CITY OF ALBUQUERQUE

**RE: 824 Candelaria NW
Grading and Drainage Plan
Engineer's Stamp Date: 2/5/25
Hydrology File: G14D099
Case # HYDR-2025-00038**

GRADING & DRAINAGE PLAN

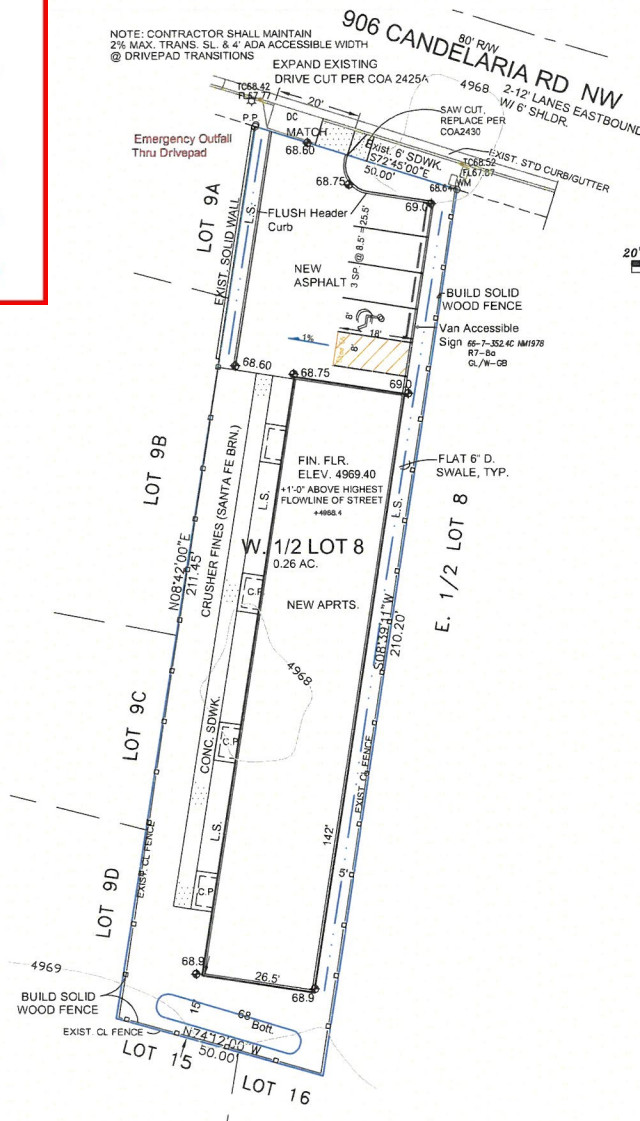
Based upon the information provided in your submittal received 02/14/2025, the Grading and Drainage Plan is approved for Building Permit and Grading Permit. **Since this site is relatively flat and grades to the road, a pad certification is not needed for this project.** Please attach a copy of this approved plan in the construction sets for Building Permit processing along with a copy of this letter.

1. Engineer's Certification, per the DPM Part 6-14 (F): Engineer's Certification Checklist For Non-Subdivision is required.
